CITY OF NELSON

2019-P-02
Coke and Gas Works Exterior Revitalization
ADDENDUM #1

Nelson Coke and Gas Works

CONDITION ASSESSMENT

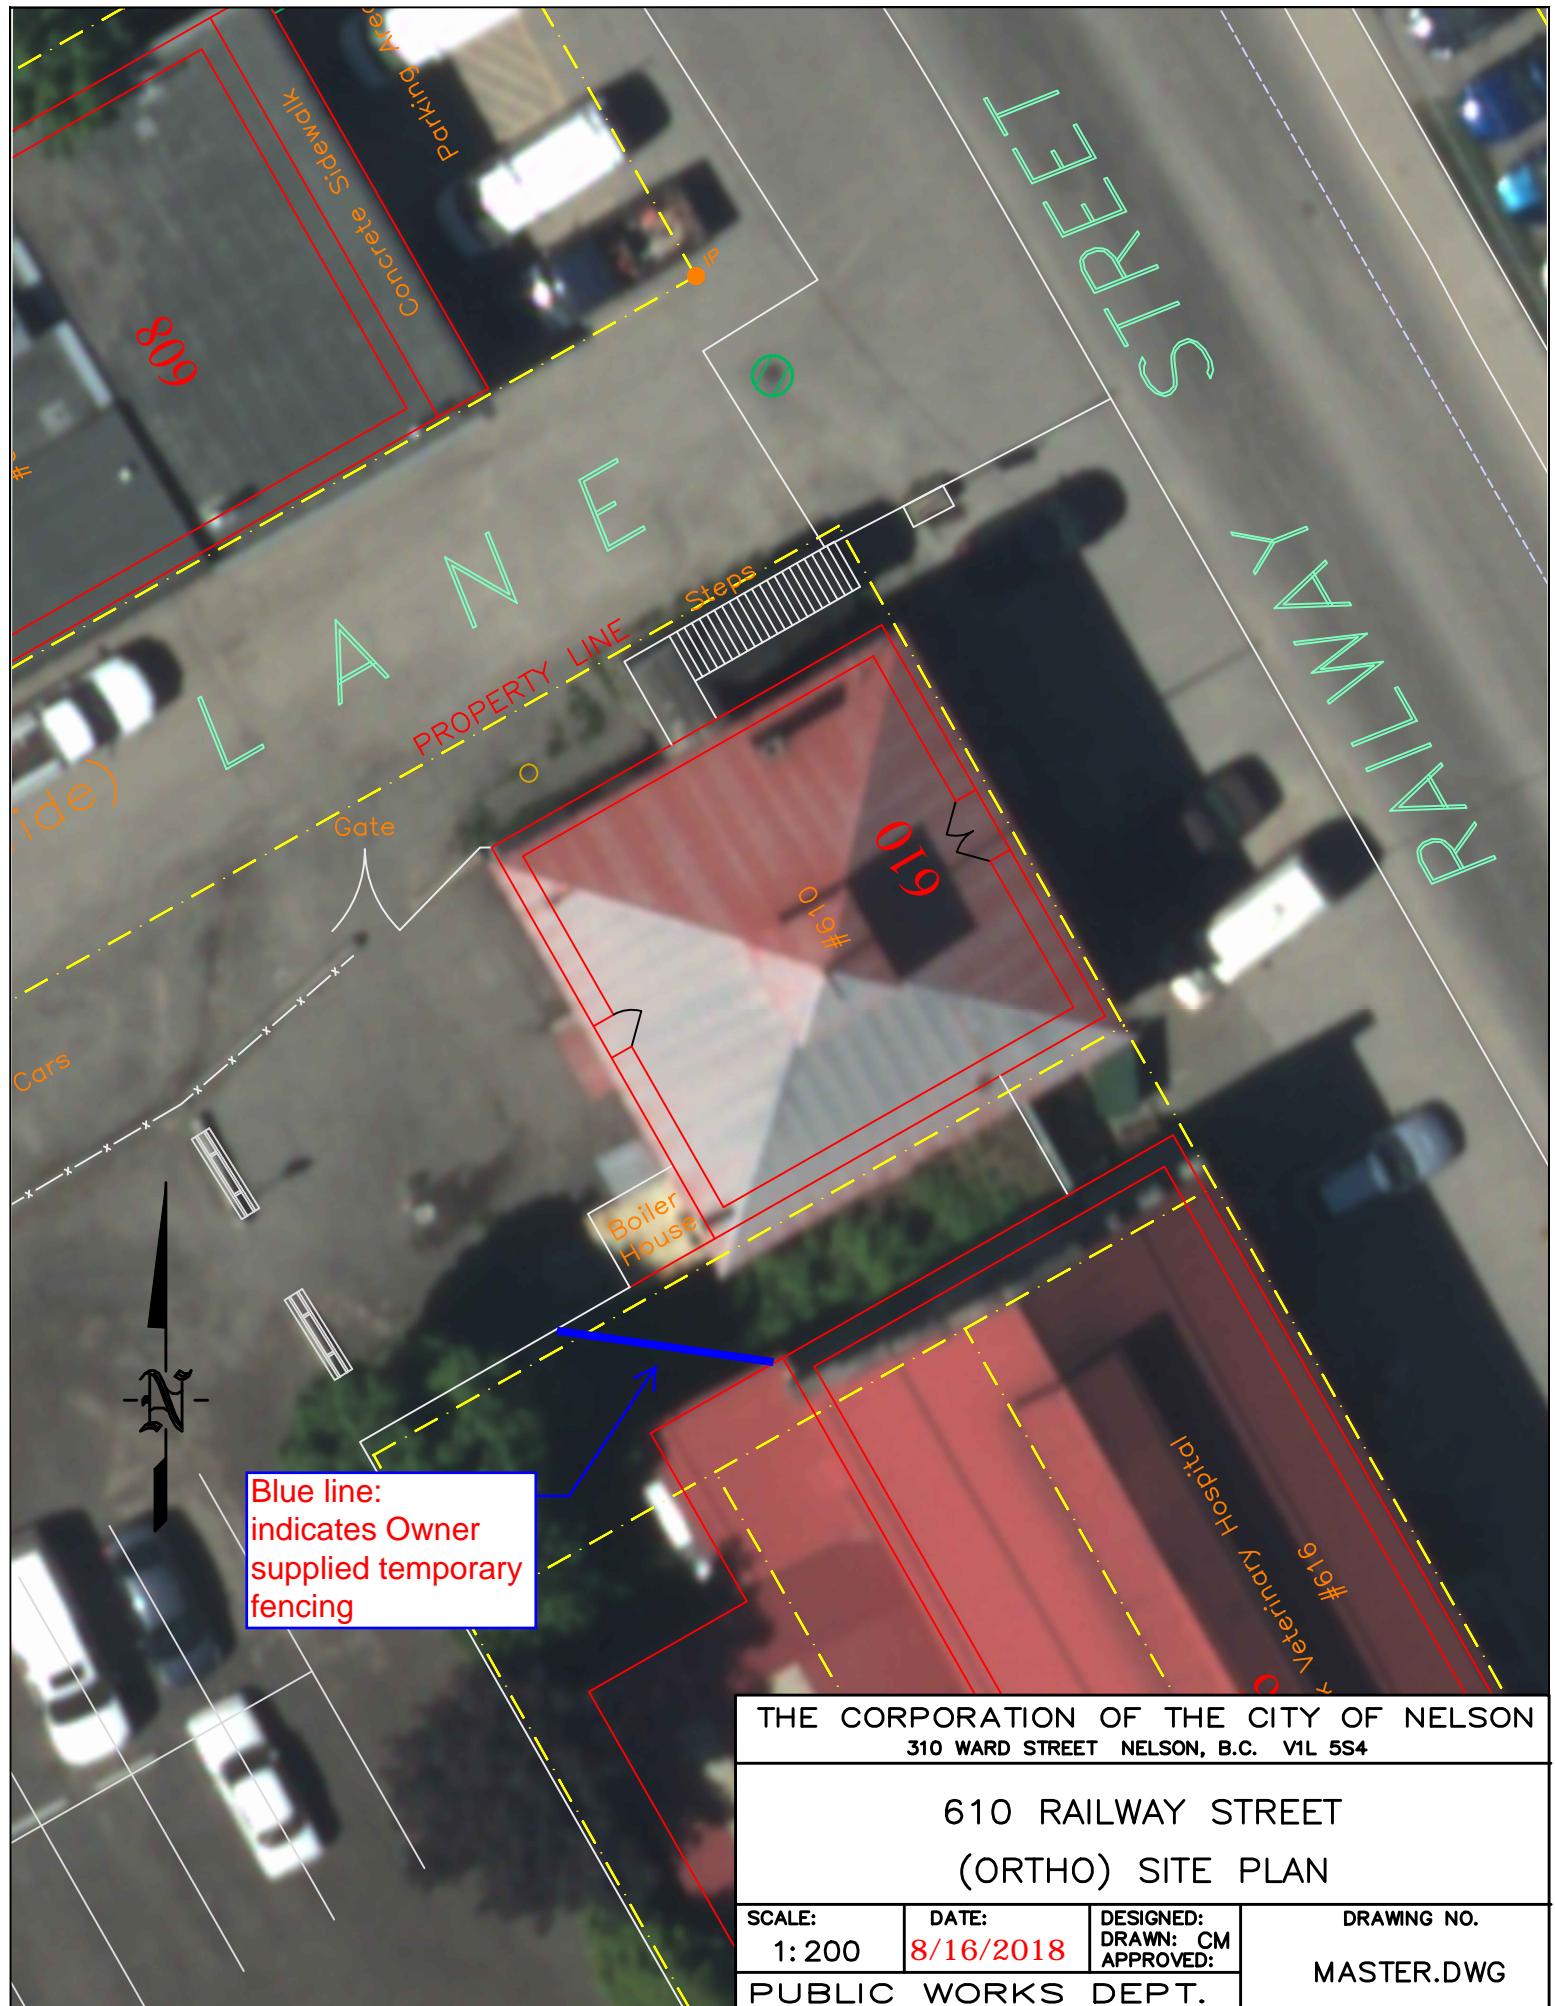
b) **Electrical mast on NE corner of roof**

The Contractor shall coordinate with the service provider for communications removal.
The Contractor shall remove the mast.
